158 STERLING ROAD

Heritage Preservation Board

April 21, 2016

REVISIONS TO PREVIOUSLY APPROVED WORK

1. SKYLIGHTS

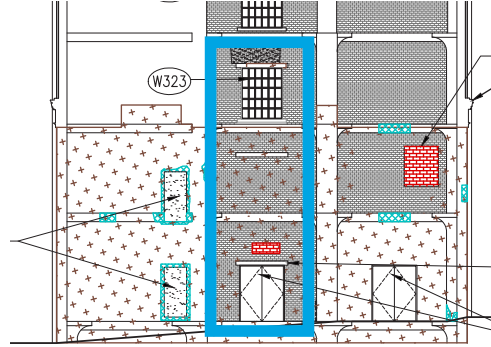
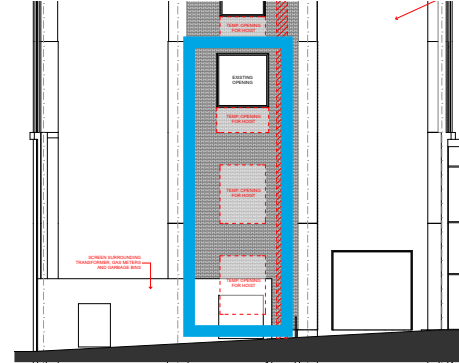
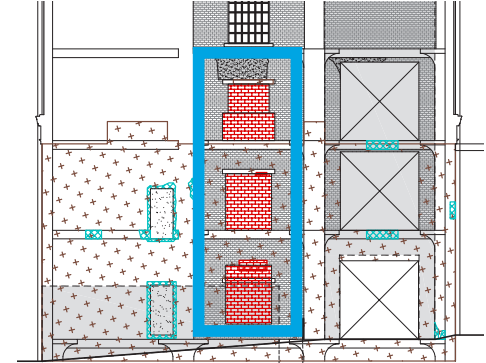
PREVIOUSLY APPROVED Removal of one skylight.

PROPOSED Removal of two skylights.

RATIONALE Required to provide additional space for rooftop mechanical equipment.

2. NORTH ELEVATION - FLOORS 1-3

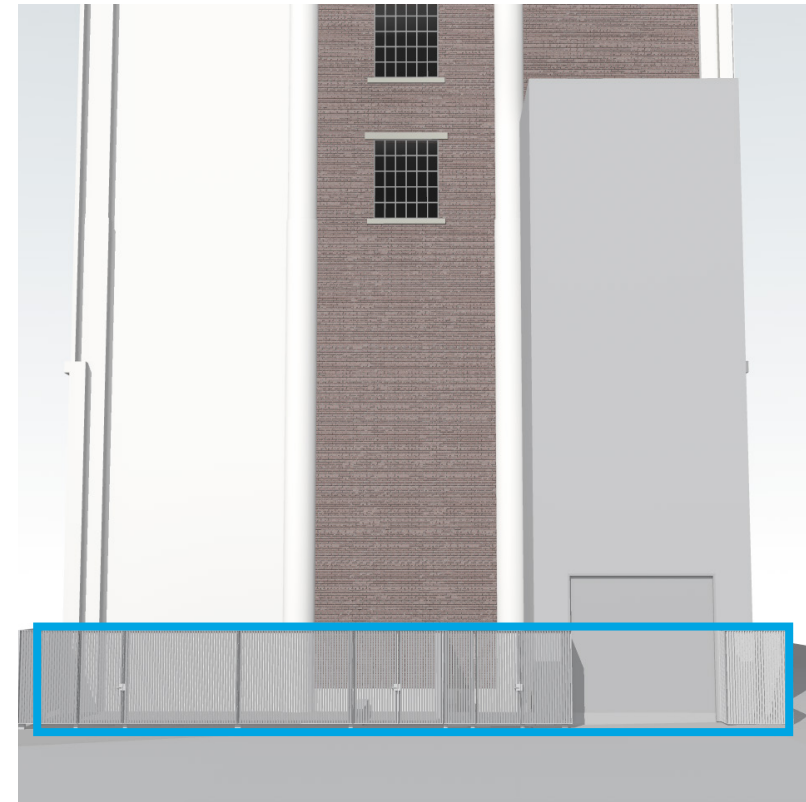
PREVIOUSLY APPROVED A new door at grade and one enlarged window opening.

PROPOSED Temporary openings for construction hoist, then in-fill with salvaged original brick.

RATIONALE Temporary hoist required to facilitate construction; location carefully selected to minimize impact on the facade. The temporary openings will be seamlessly in-filled with salvaged brick, consistent with the original condition. The in-fill will also respond to the needs of the tenant, as MOCA does not want windows on their proposed exhibition floors.

1. METAL LOUVRE SCREEN (NORTH ELEVATION)

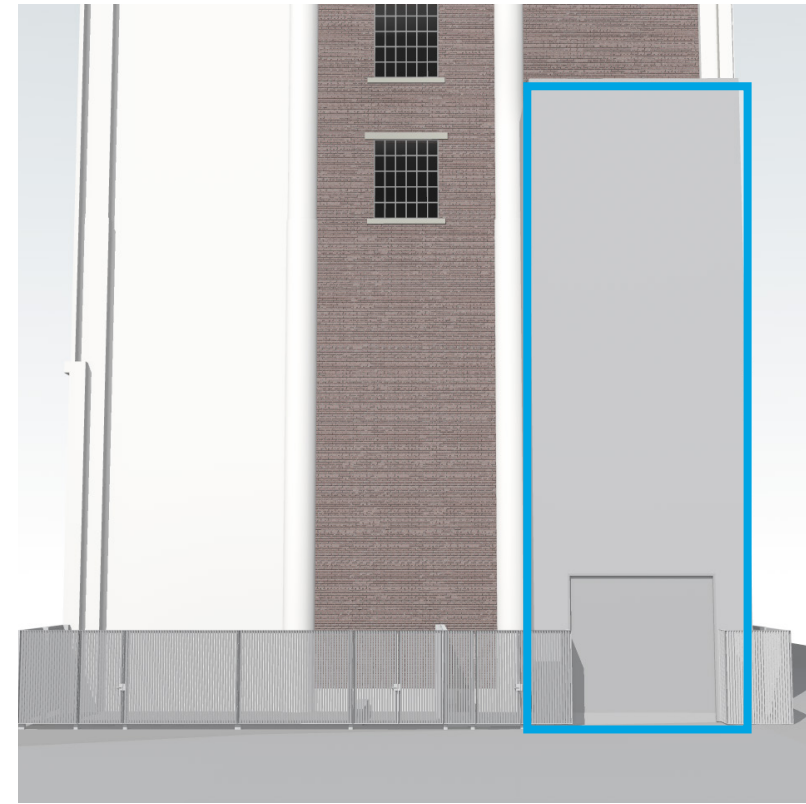
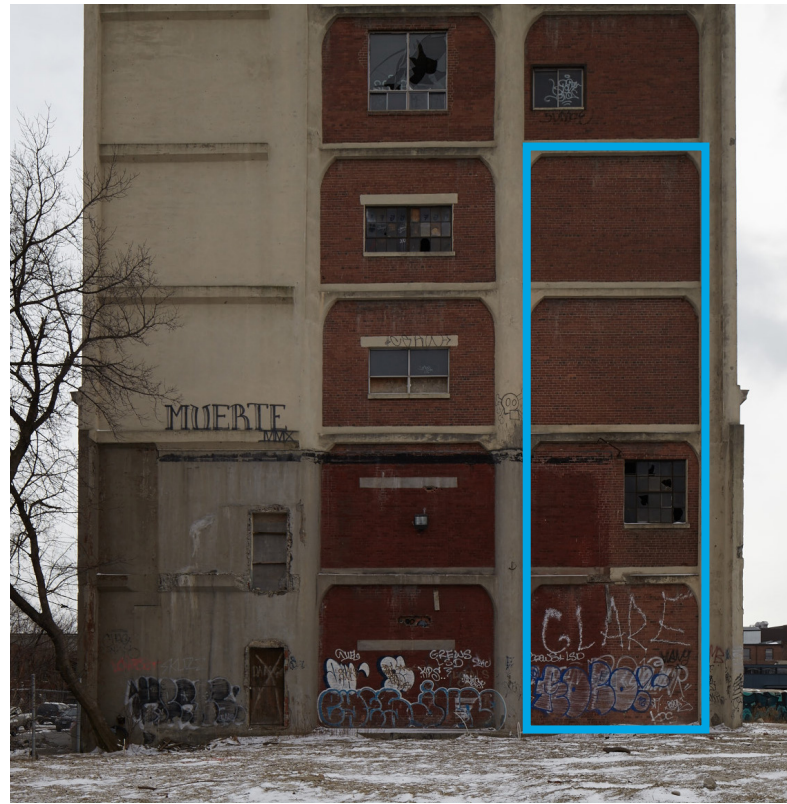
PROPOSED Proposed new screen along the north elevation surrounding the addition of a gas meter, transformer and garbage storage area, which are required to service the building.

RATIONALE North elevation is the most appropriate location because its design is 'unfinished,' as the building was always intended to be expanded further north.

2. FREIGHT ELEVATOR (NORTH ELEVATION)

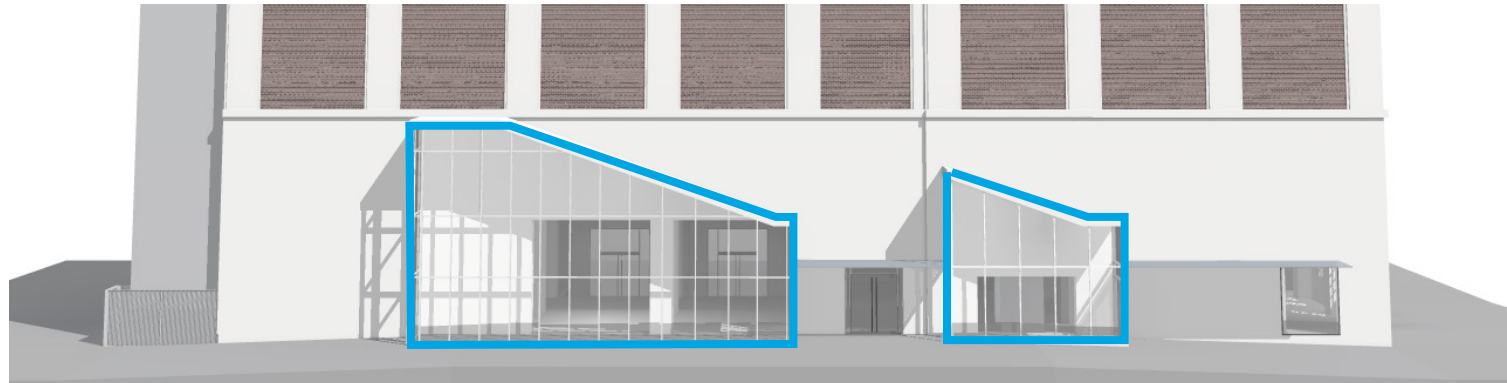
PROPOSED External 3-storey freight elevator.

RATIONALE North elevation is the most appropriate location because its design is 'unfinished.' The new elevator must accommodate the museum's unique loading requirements (very specific climate control conditions and size restrictions). A new *interior* shaft would have resulted in major structural and costly modifications to the interior of the building, as well as a dramatic reduction of usable floor area. It is also questionable if a new freight elevator could be internalized since the pit likely could not extend to the basement due to hydro-geological reasons. MOCA intends to commission murals for the external cladding of the freight elevator, which will offer an unique programming opportunity.

3. GLASS VESTIBULES (WEST ELEVATION)

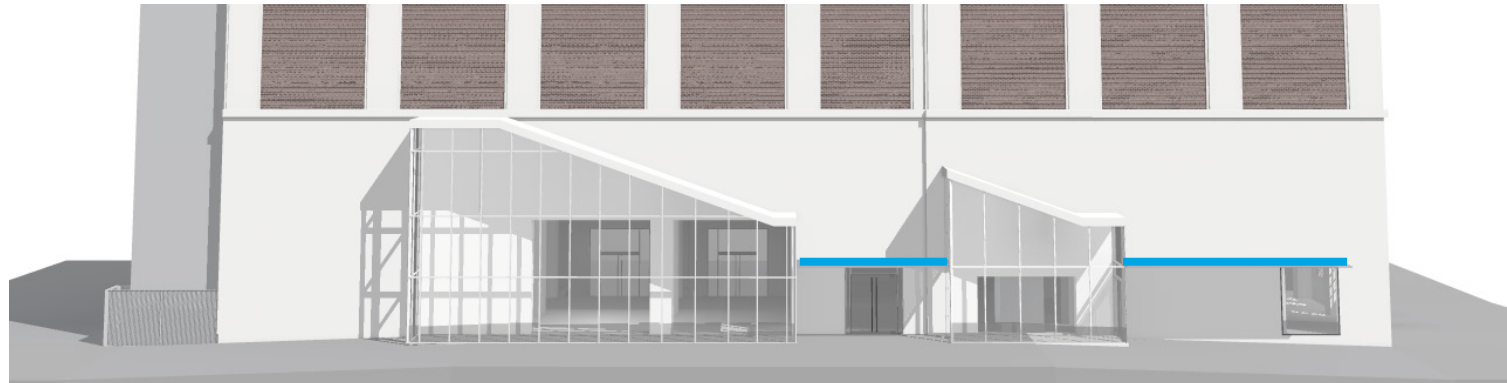
Two glass additions:

- The larger volume will connect the museum floors with an interior stair and will connect the proposed cafe area with the publicly accessible plaza area (which will be used by MOCA for outdoor events);
- The smaller volume will be a vestibule and entrance for the offices above.

The modern additions will interpret the 'ghost lines' of previously demolished triangular sheds that formerly abutted the building. The transparent material choice will mark these as contemporary interventions while maintaining the legibility of the historic building.

4. ENTRANCE CANOPIES (WEST ELEVATION)

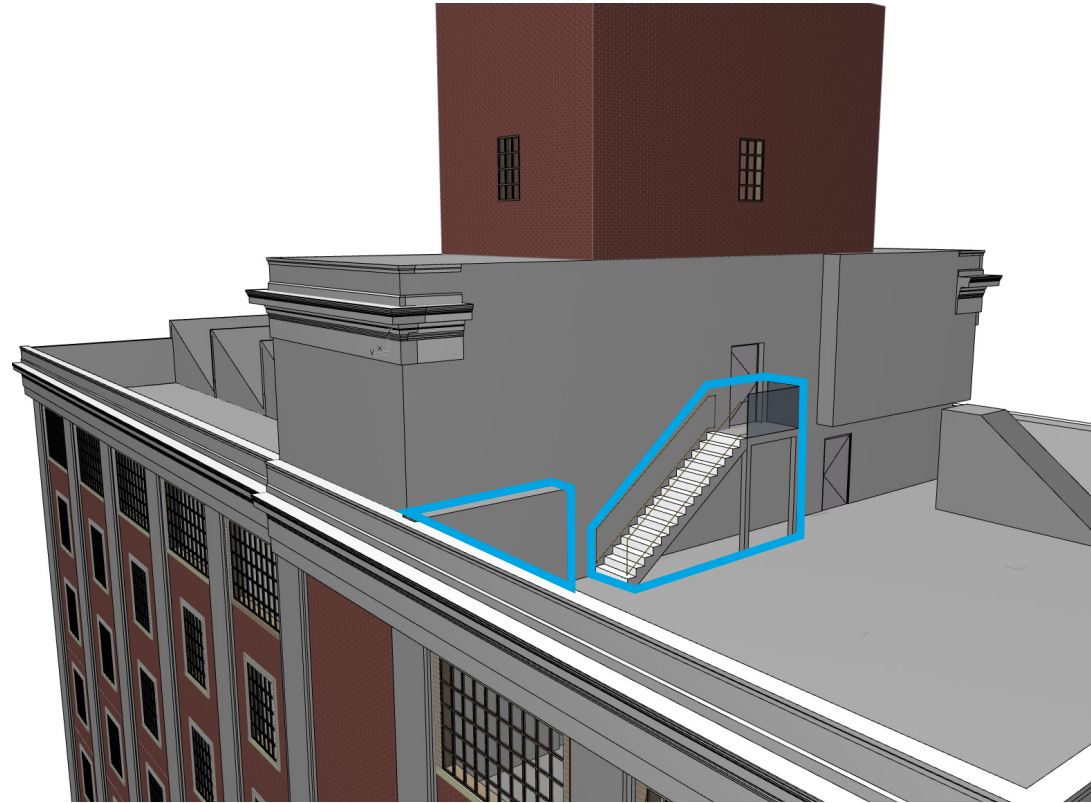
PROPOSED Two laminated glass canopies on the ground floor, fastened to building with metal brackets.

RATIONALE Mark the main entrances using contemporary materials distinguishable from the heritage fabric.
